| County | Plan No. | SP-17-0 | 0Z; AMENDSP-27-03 SBVRG CANDING Phase 2 |
|-----------------|--------------------|-----------------------------------------|------------------------------------------------------------|
| | Name: | WILLAM | SBURG CANDING Phase 2 |

| Project Name: ; Williams bur 9 Landing Bmp#2 |

Plan No.: SP-17-02; amended SP-27-03 BMP ID: CC 025 (Wet Pond BMP # 2)

Re: Williamsburg Landing Phase 2
County Plan No. SP-17-02: A-mail 157-564

OUTFALL STRUCTURE 1

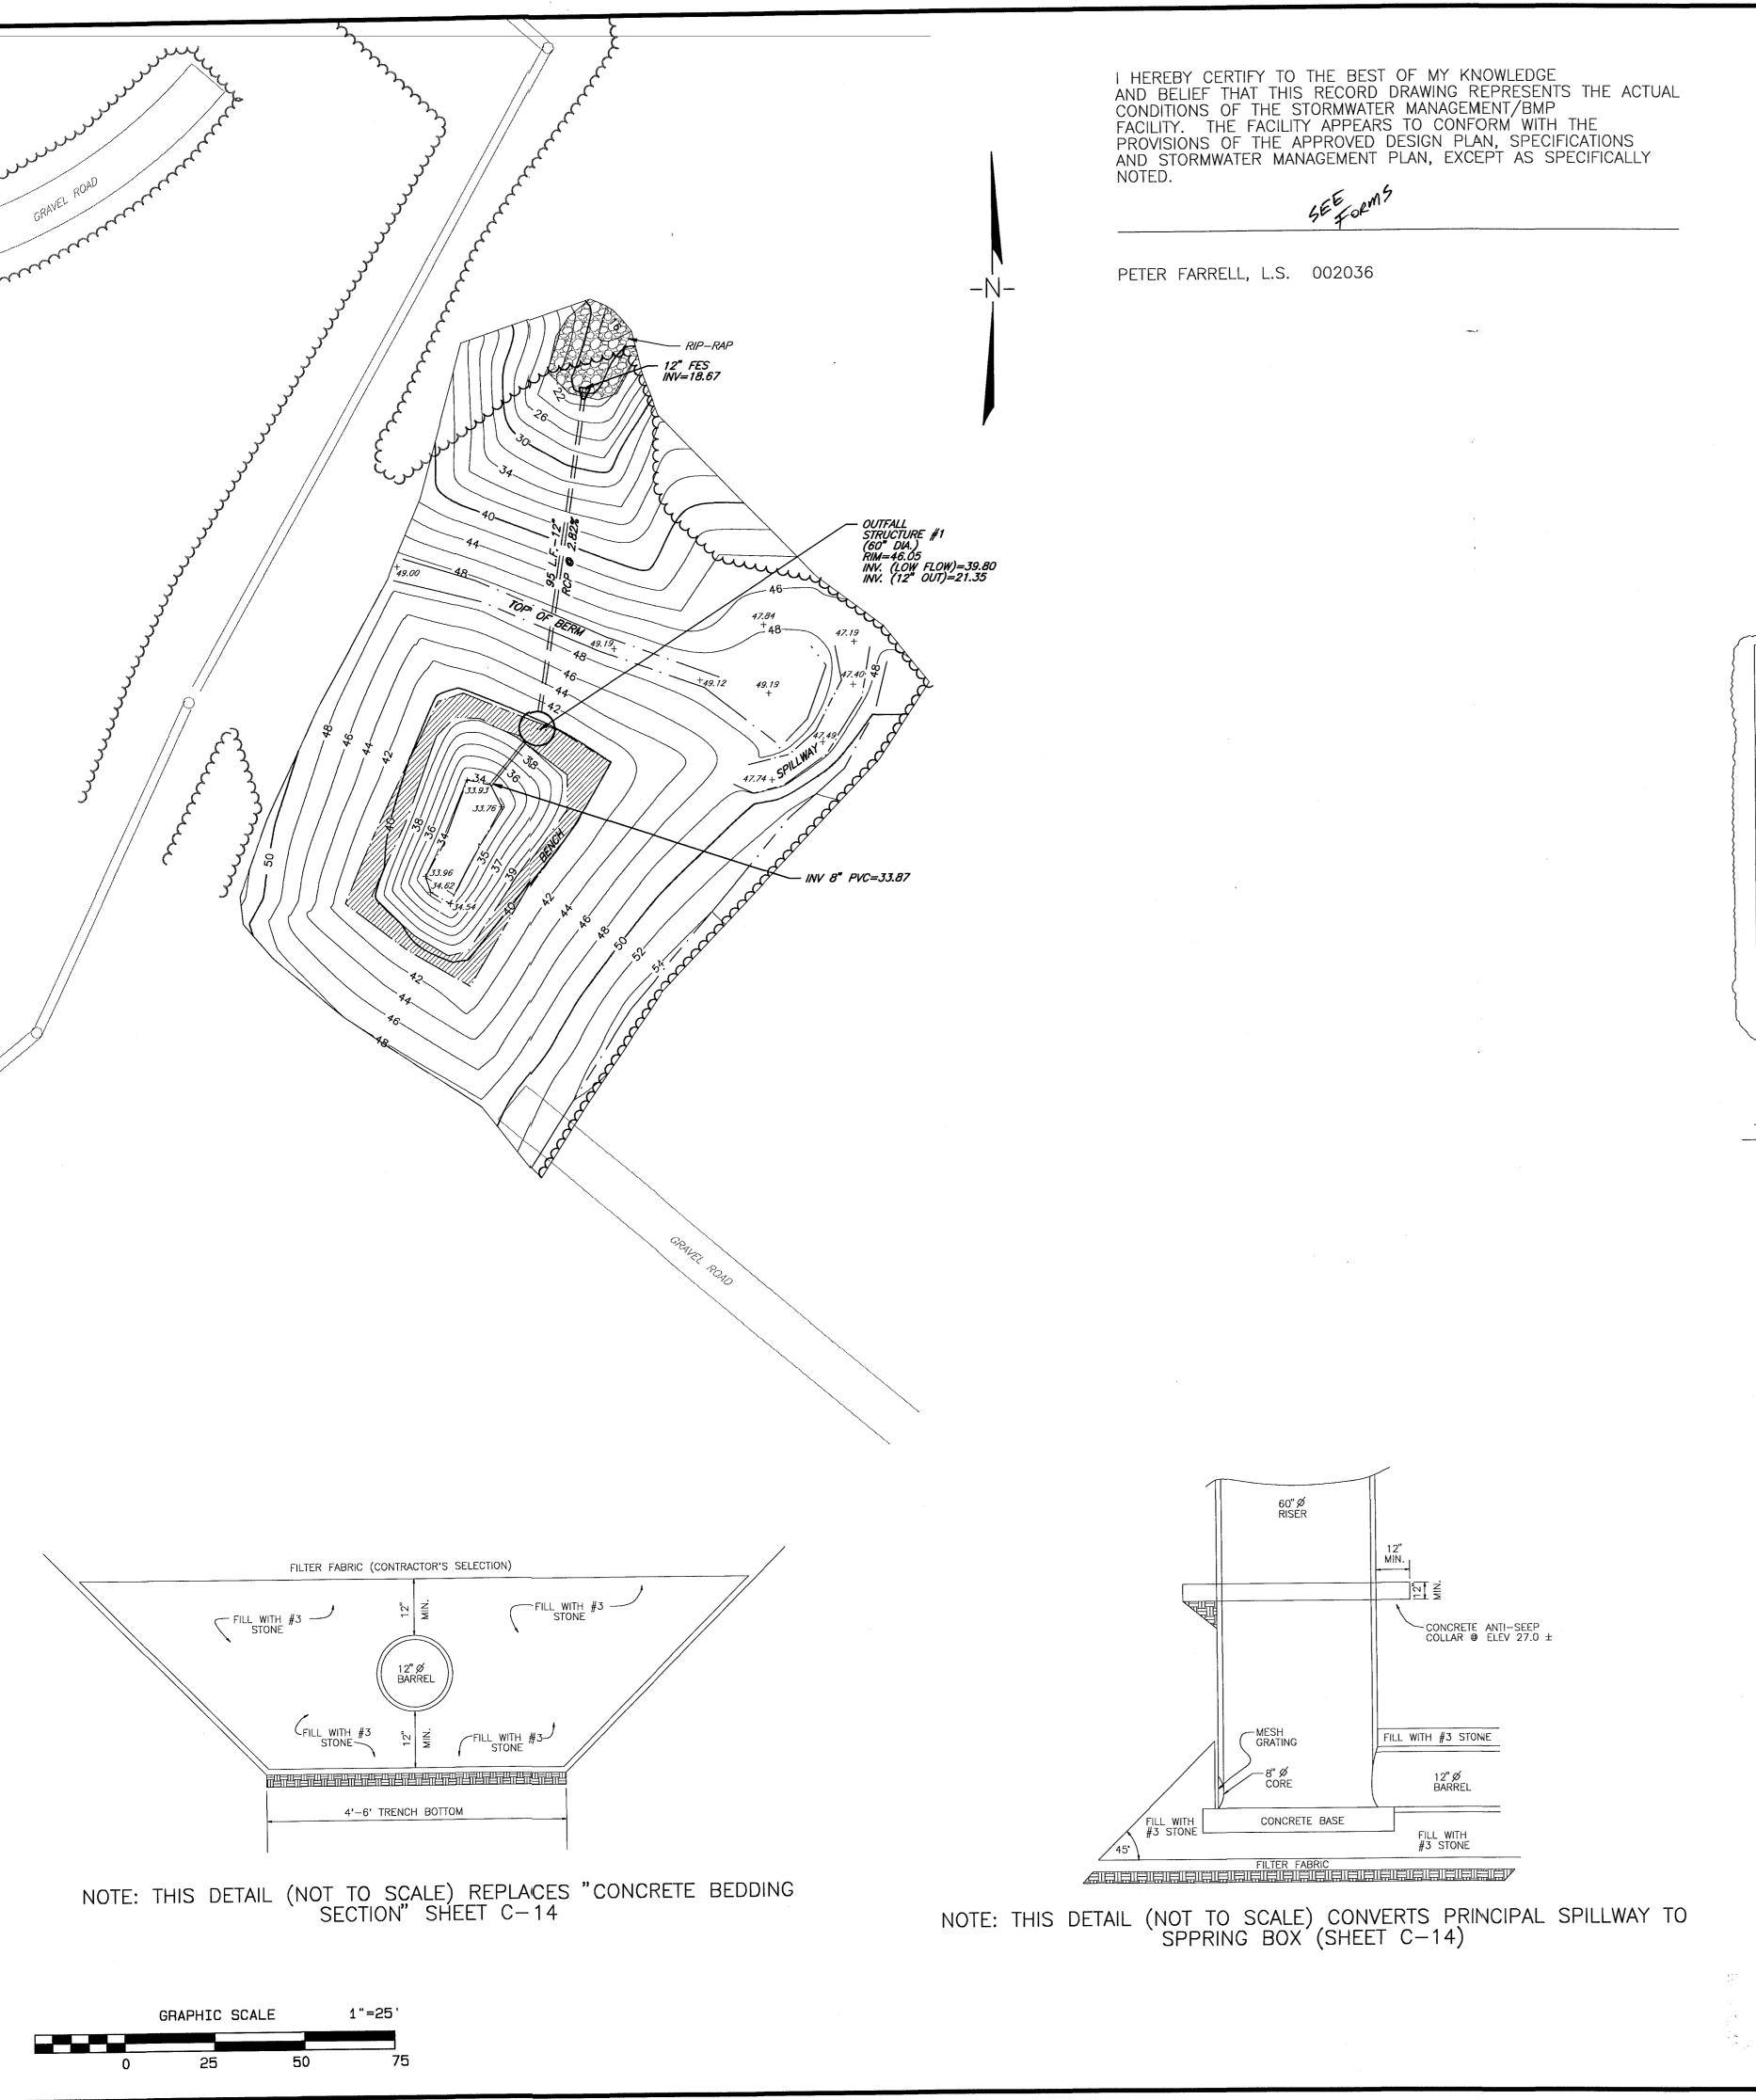
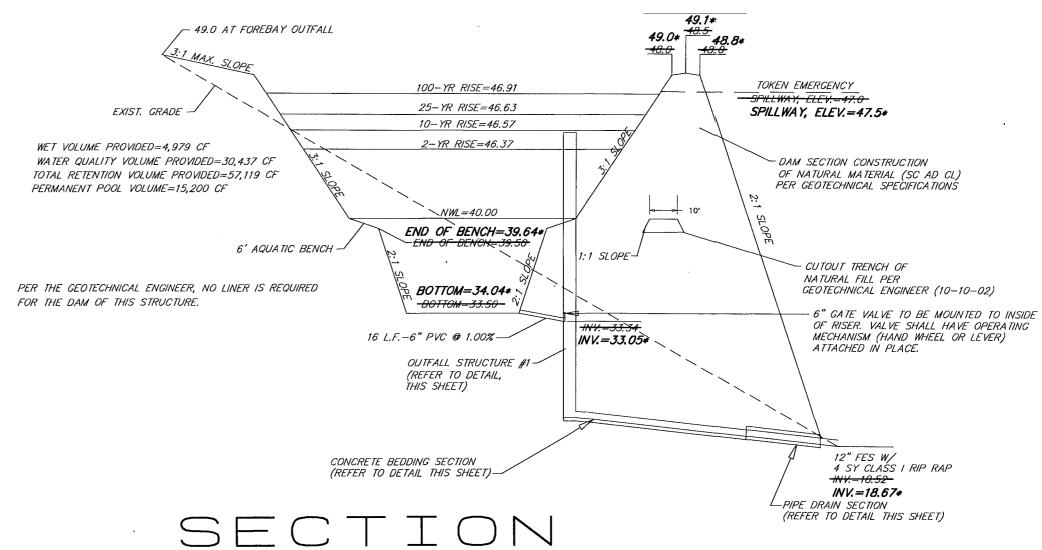
The "Outfall Structure 1" detail on interim record drawing Sheet R-2 (2 of 2) must reflect changes that were recently made to the primary discharge (riser/barrel) structure due to unexpected field conditions that were encountered. Field changes included converting the principal spillway to a spring box, adding a vertical concrete anti-seep collar and use of stone bedding under the barrel to serve as an under drain mechanism.

| To: | SCOTT TH | HOMAS, PE | | | | | | | | |
|----------------------------------------------------------------------|--------------------------------------------------|--------------------|--------------------------------------------------------------------------------------------------------------|--|--|--|--|--|--|--|
| Notes: SCO THE D | | THE OUTFALL STRUC | TURE REVISION HAS BEEN ADDED. | | | | | | | |

Date Comment By
7/11/03 Added revised BMP details CRO
